Planning Commission

Regular Meeting Agenda

April 22, 2024 | 6:30 PM

MEMO TO: Planning Commission

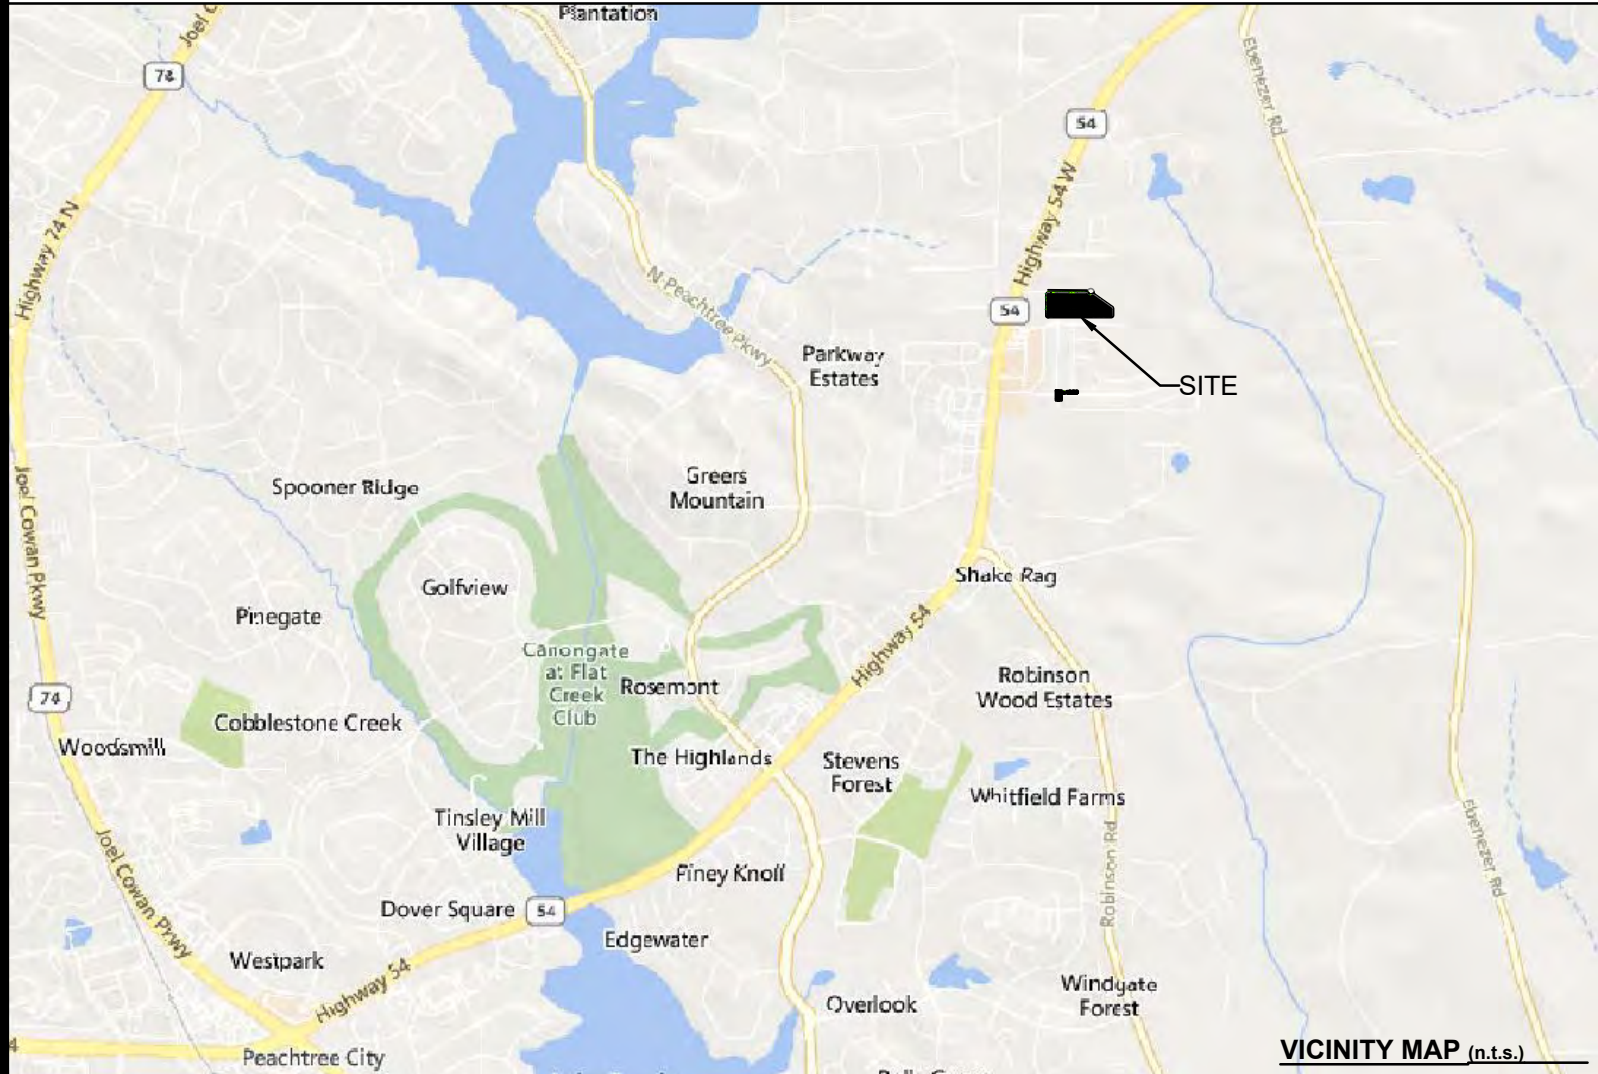
- A maximum of 75 percent of the total development shall be used for residential-only uses. All uses and conditional uses listed in the GR zoning district shall be permitted, subject to the same requirements and conditions.
 - o Staff Comment: Combined with the Towson Place single-family residential neighborhood, the Peachtree Court townhomes will result in a total of 55.5 acres of the 75-acre development used for residential-only. This equates to 73% of the total land being used for residential-only uses.
- Maximum 12 dwelling units per acre for attached residential.
 - o Staff Comment: The proposed plat shows 38 lots. This is a density of 6.9 du/acre, thereby meeting this requirement.
- A 50-foot right-of way shall be dedicated to the City for a future street connection

- to the southern property line abutting the Shiloh Mobile Home Park.
 - o Staff Comment: The conceptual plat shows a street-stub to the southern property line, thereby satisfying this zoning requirement. Using the plat scale, the right-of-way shown on Road A is 50 feet. In addition, the details page C201 also shows Road A as a 50-foot right-of-way.

- Sidewalks shall be provided on Peachtree Court.
 - o Staff Comment: sidewalks are shown on the development's side of Peachtree Court. In addition, a 4-foot sidewalk is shown on one side of Road A on the details sheet. This is not required by the ordinance, but is provided in addition by the developer.

- Parking ratios shall be a minimum of one per attached dwelling unit.
 - o Staff Comments: 2 garage parking spaces are shown per unit. Although the garages are shown as detached, this level of detail is not required by the city's ordinances. In addition, 27 off-street parking spaces are evenly distributed throughout, allowing for visitor parking. This exceeds the zoning requirements.

- o Staff Comment: Although this level of detail is not required on a concept plat, the plat shows the street trees as required.
- Maximum building setback from Peachtree Court shall be 12 feet.

- o Staff Comment: the concept plat satisfies this requirement.
- Side setbacks are zero, provided the fire codes are satisfied and that there is at least 10 feet between detached buildings.

TOWSON PLACE
TYPICAL LOT LAYOUT

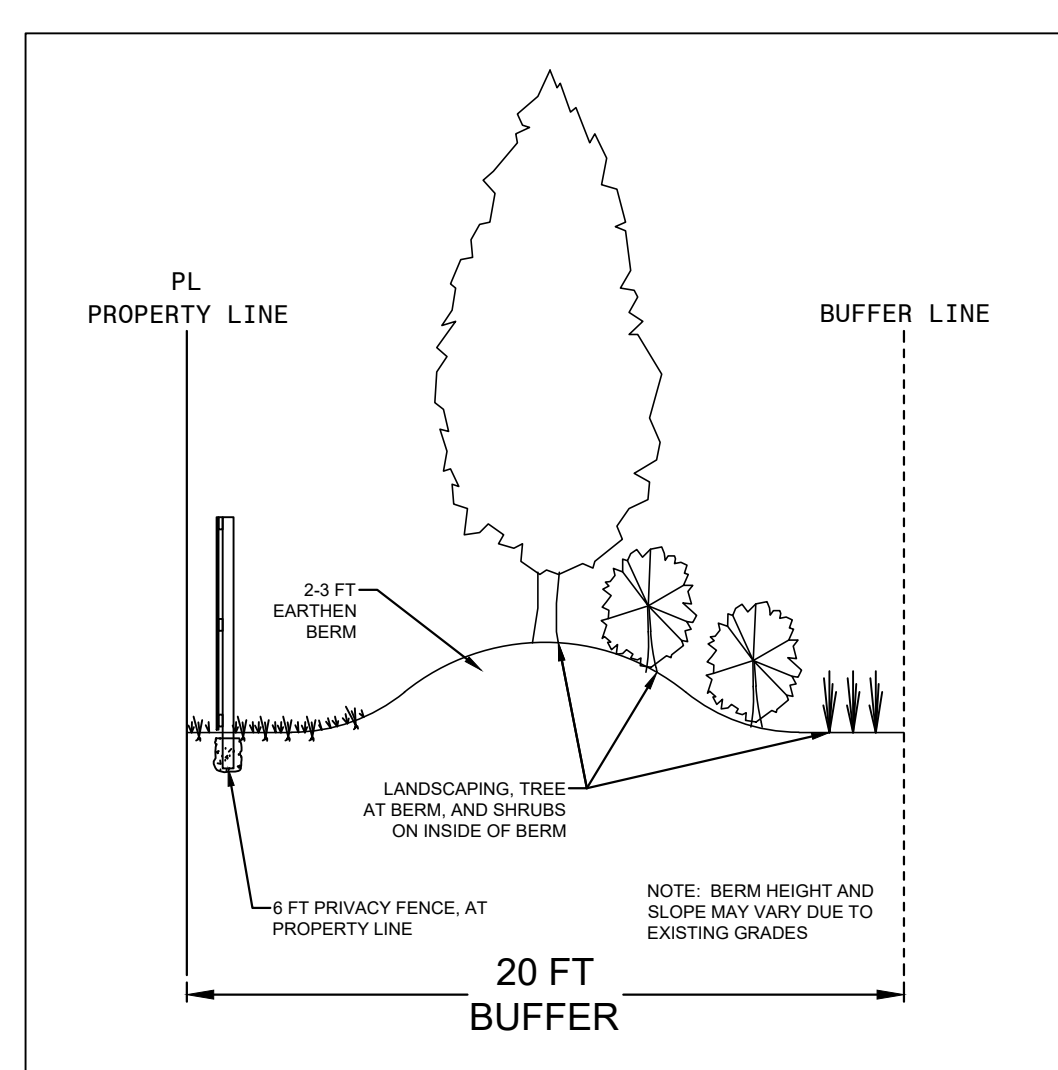
6. A plan note on sheet C201 in the Typical Lot Layout Sketch indicated some end units are 30ft wide where available. Is this note referring to the lot width or unit width or both? In any case this should be clearly depicted on the plan and stated

This note refers to the lot width at the end units, or a 5" easement. The units will not exceed 25' for the foundation. The goal here is to allow for either a landscape extension of the courtyard on that side or a bay window, awning or other architectural detail(s) which would not require a foundation. The goal being to create some texture along the ends of the buildings.
